Design Response Conference 8/25/2009

Building A Massing & Material Modulation

Notes from 8/31/09 DRB Meeting

**Master Plan and Design Guidelines
Page DG – 20 – All Districts: Bldg. Design**

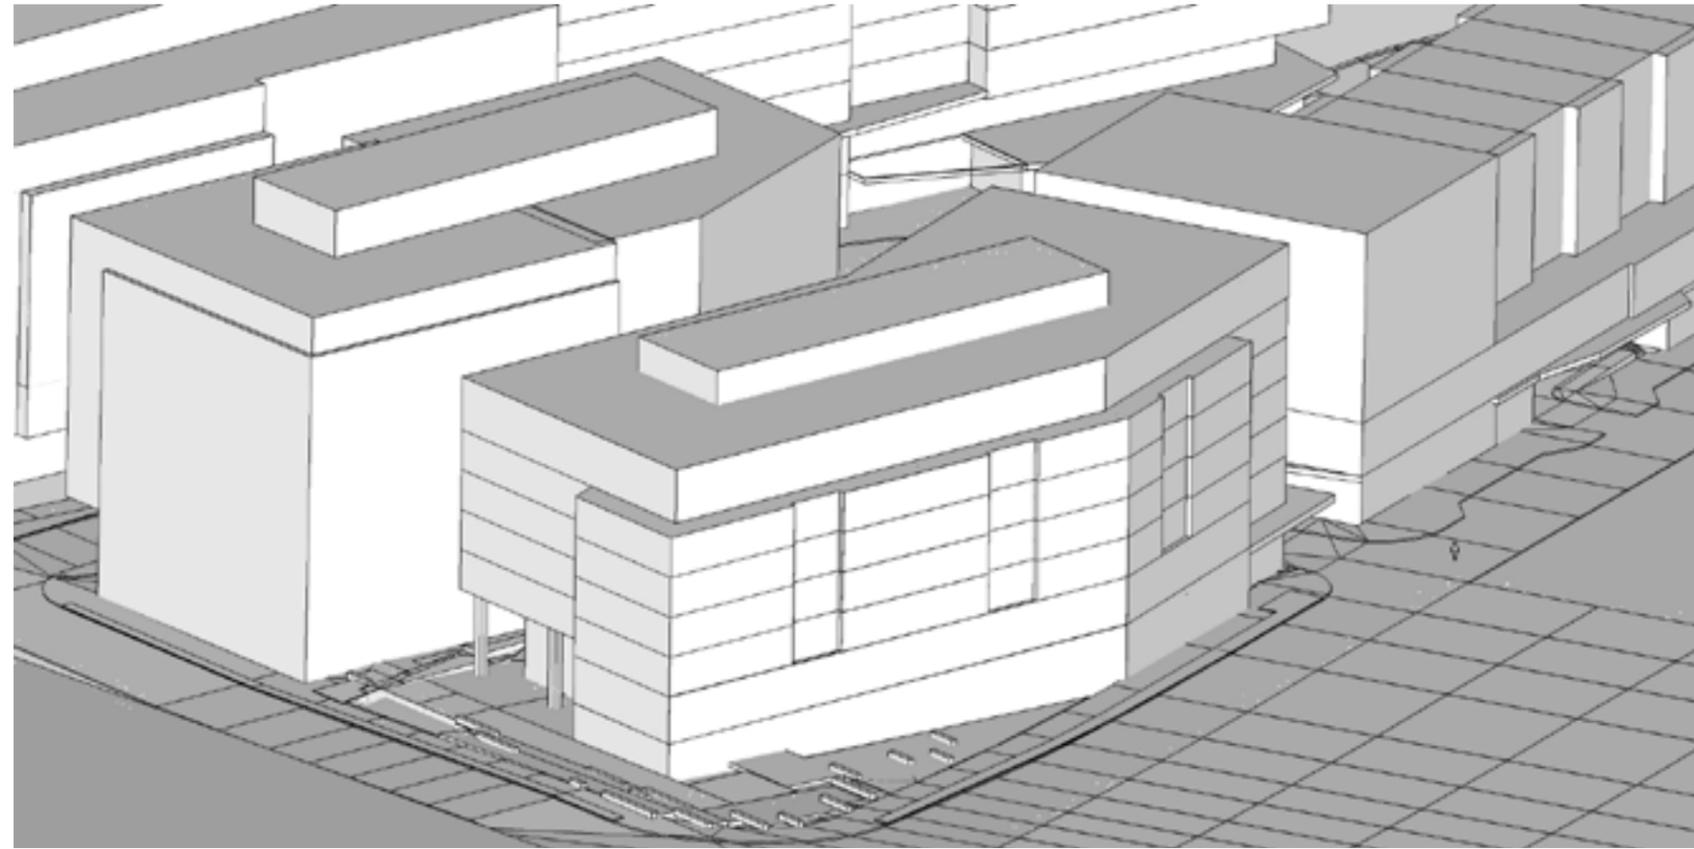
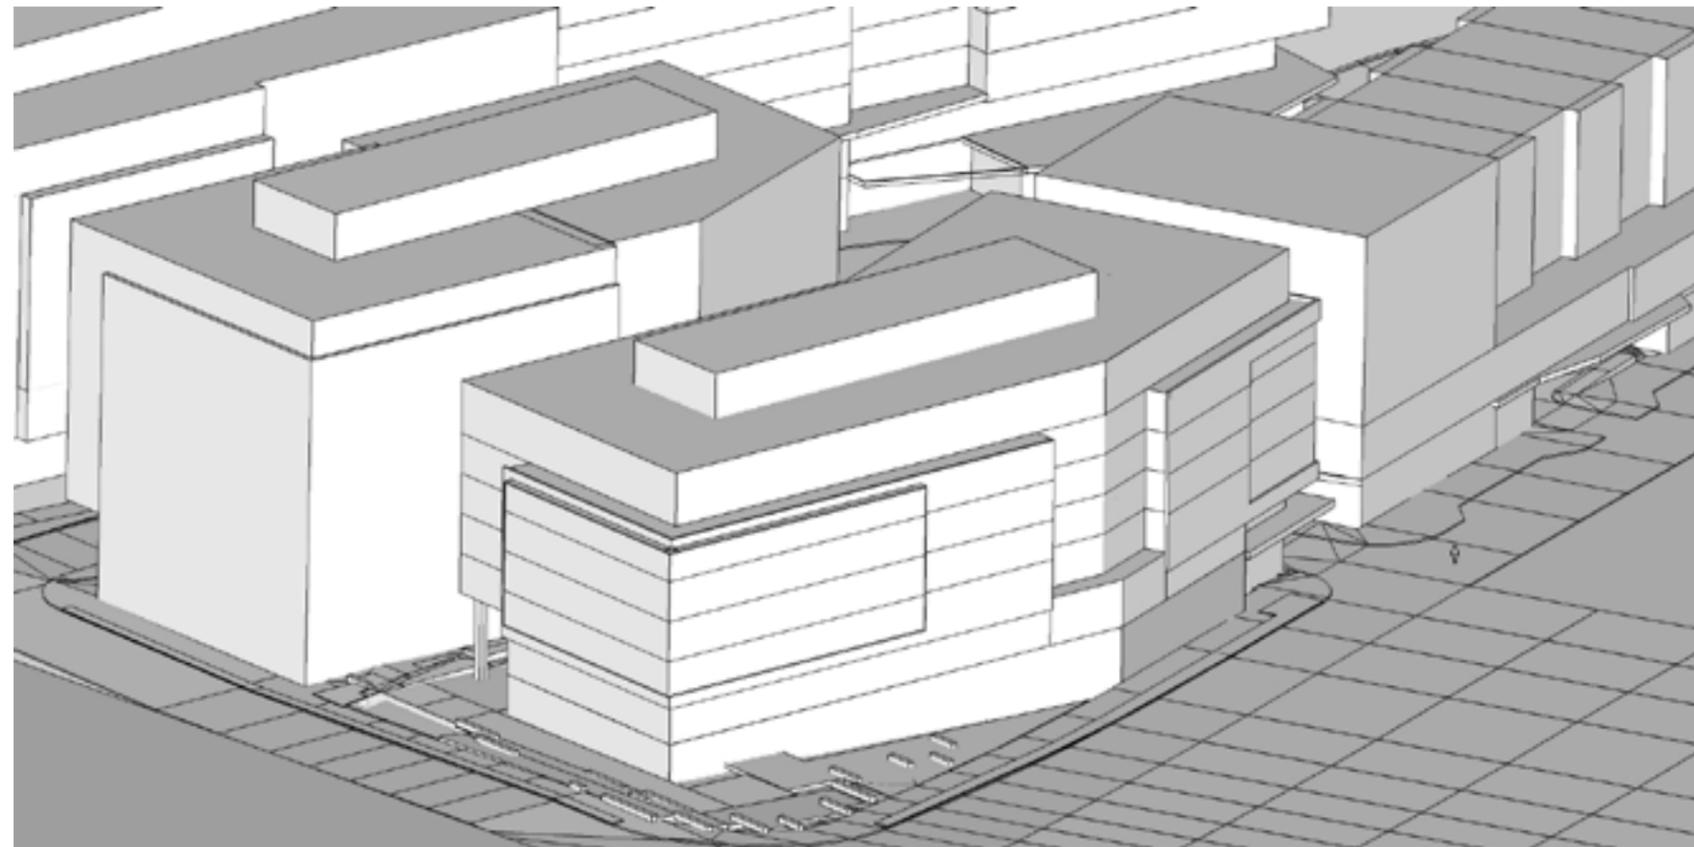
DRB comment: Is order important? Classical or more abstract?

Response: We believe that order is very important. Our facades strike a balance between the classical concept of base/middle/top, which the buildings have, and a more abstract elevation concept that lends movement and informality to the architecture.

**Master Plan and Design Guidelines
Page DG – 20 – All Districts: Bldg. Design**

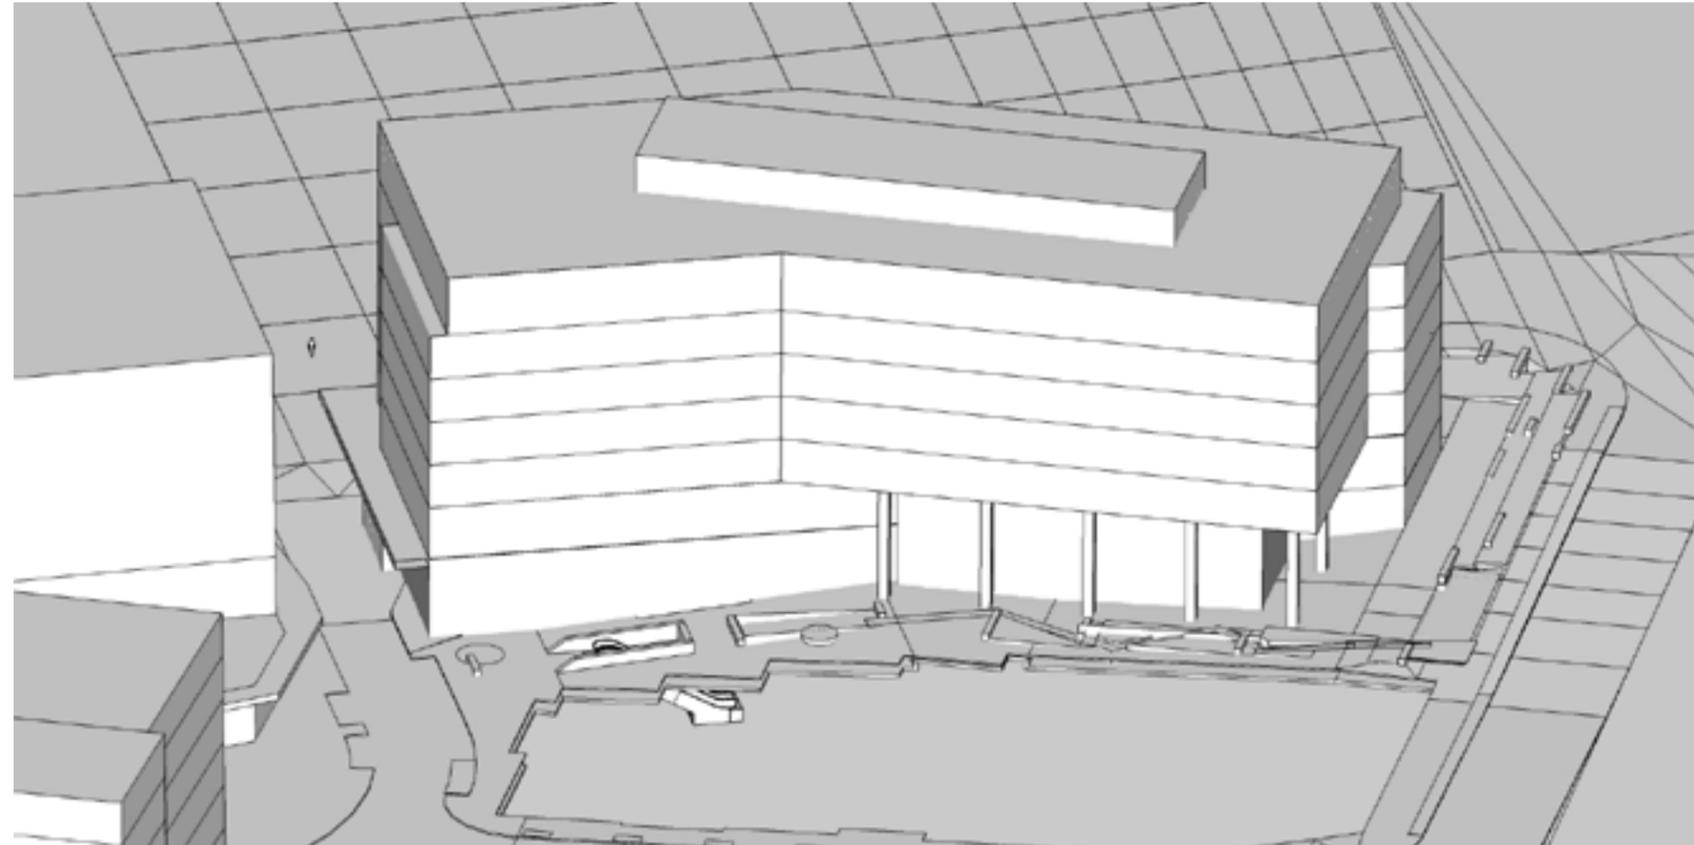
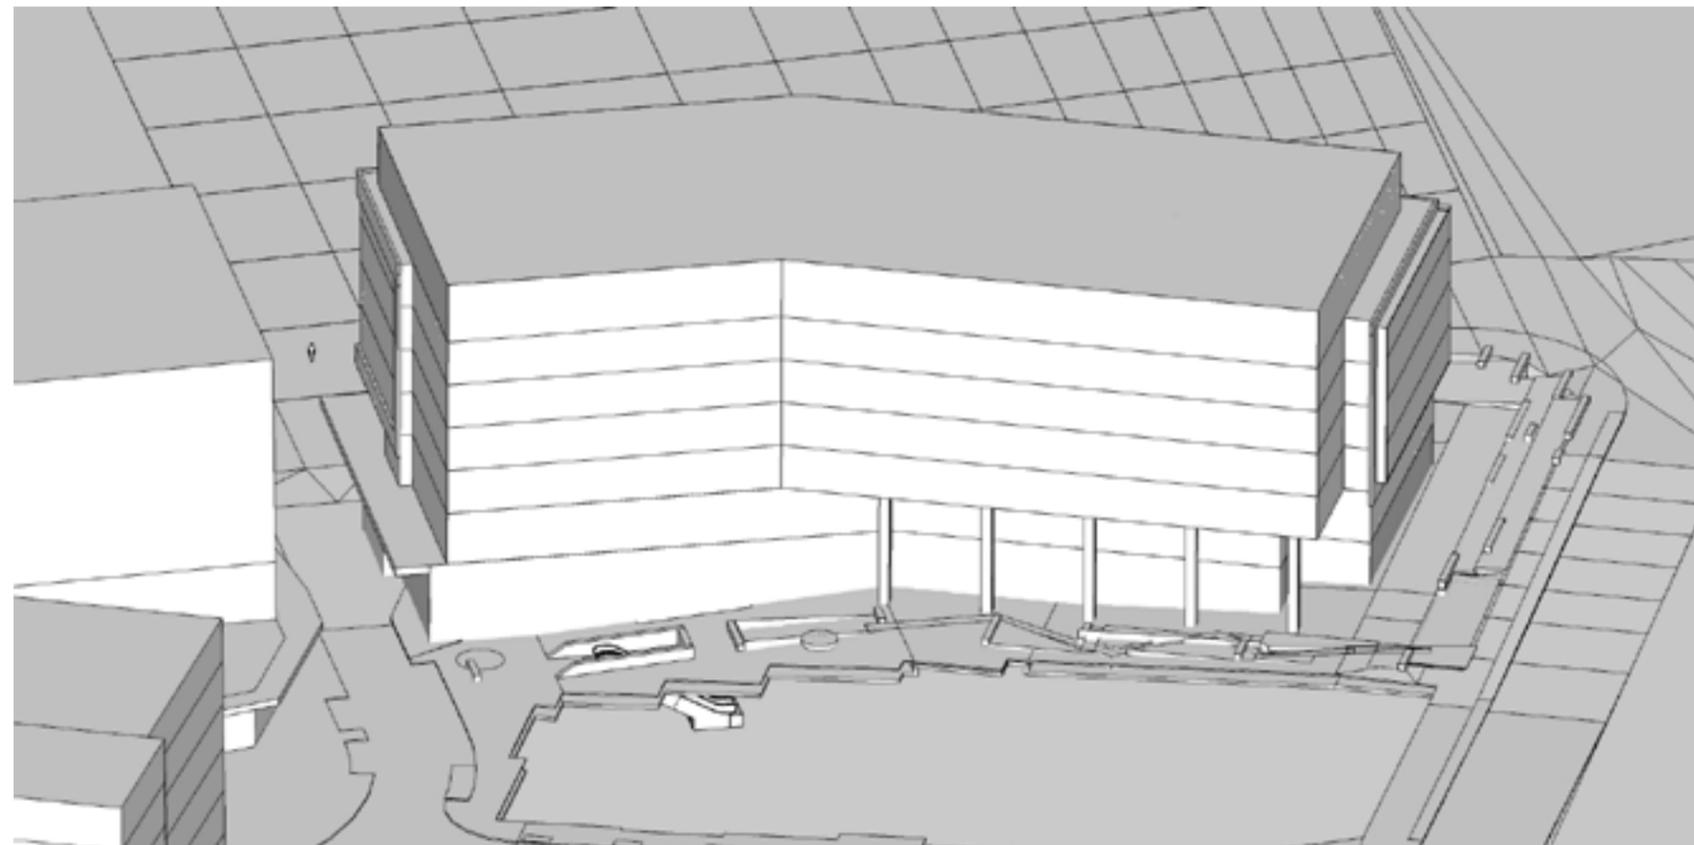
DRB comments: BIG PICTURE: What's important? Order & scale, base, roof edge.
f. Be careful windows don't look like ribbon windows.
g. Use major architectural expressions for important gateways & intersections. Buildings B & C need more of this. Where is the entrance to Building A??

Response: We have avoided the use of ribbon windows throughout the design. The massing and articulation of the buildings emphasize key entries to the site as prescribed in the Design Guidelines. Building A's entrance is off the pedestrian street on the south side, opposite Building B's entrance. Its detailed design will be presented once the massing concept for the building is approved.

**Master Plan and Design Guidelines
Page DG – 20 – All Districts: Bldg. Design**

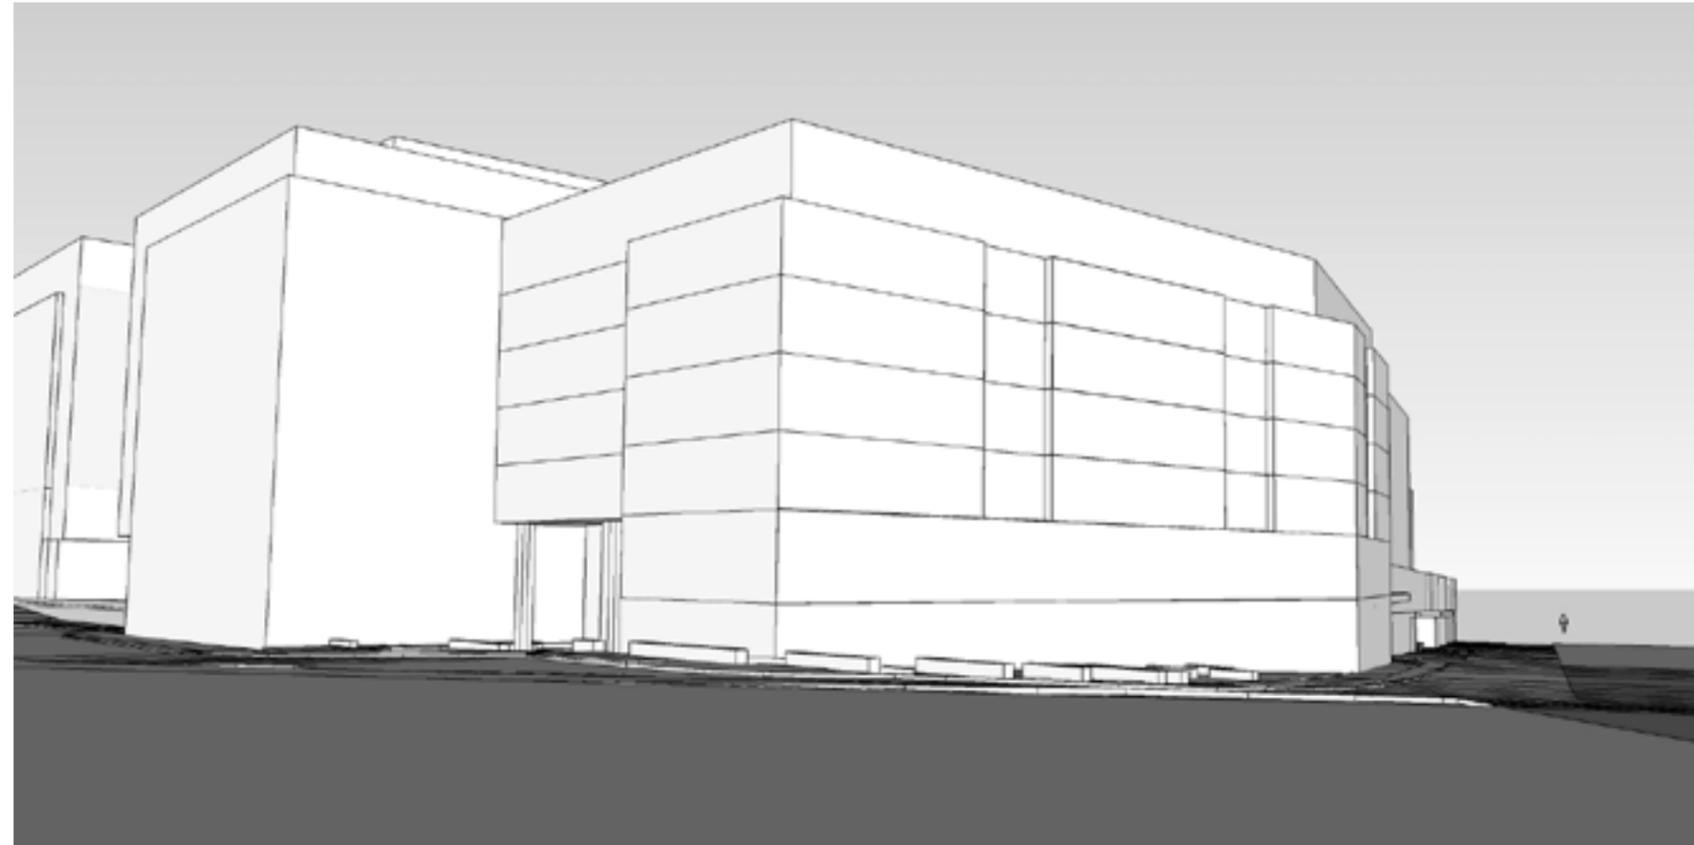
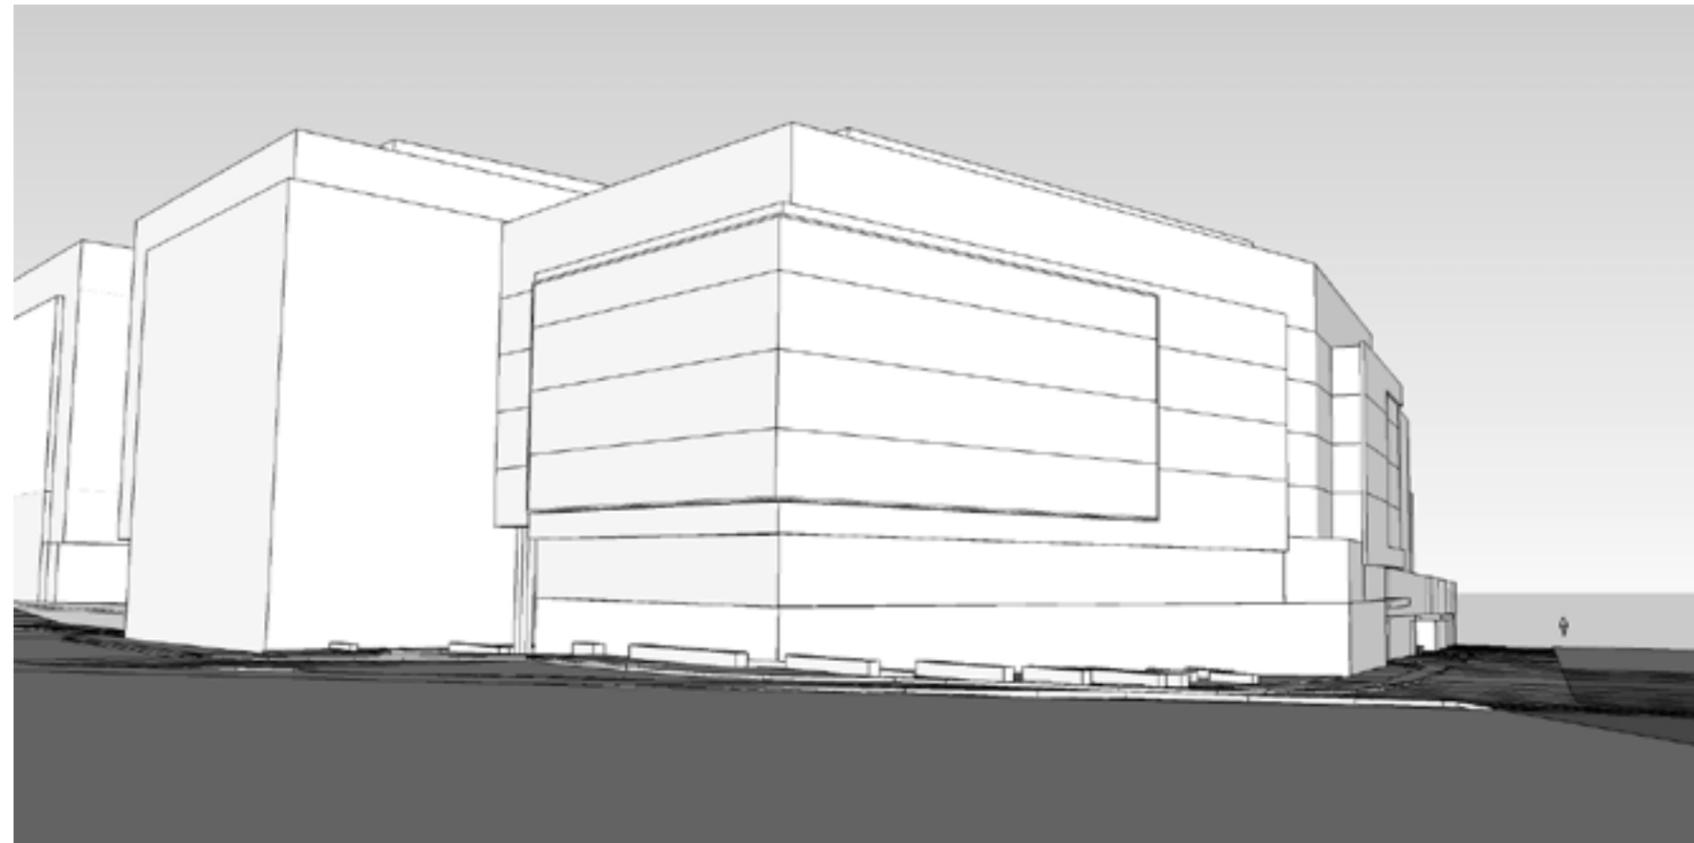
DRB comments: h. Building modulation: same discussion as e above (e. Provide clear pattern of building openings. Windows, balconies and bays should unify a building's street wall and add considerably to a façade's three-dimensional quality.).

i. Roof Silhouettes – Scale & massing comes first and then roof solution will follow.

Response: The strong articulation of the horizontal modulation on the revised Building A design will be visible against the sky from the street level, enlivening the building's profile consistent with the intent of the Design Guidelines.
